**NUMBER:** 05-88-21R

# **SERVICE BULLETIN**

SUBJECT: Front Stabilizer Bushing- Design Change

Knocking / Squeaking Sound

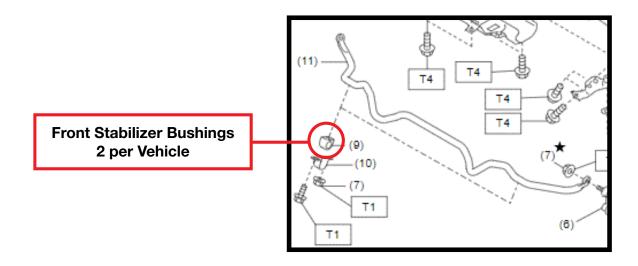
This bulletin announces a design change made to the front stabilizer bushings. The bushing material has been enhanced to address knocking / squeaking sounds when driving on rough roads during low ambient temperatures. If confirmed under the described driving conditions, the bushings shown in the illustration below should be replaced.

The new front stabilizer bushings have been incorporated into production as per the table below:

Model	Part Number	Part Description
Forester	20414SG001	
Crosstrek	20414SG001	
WRX	20414SG001	
Impreza Outback	20414FL00B	
	20414FL01B	BUSHING-STABILIZER
	20414XC00B	
	20414AL00B	
Ascent	20414XC00B	
Legacy	20414AL00B
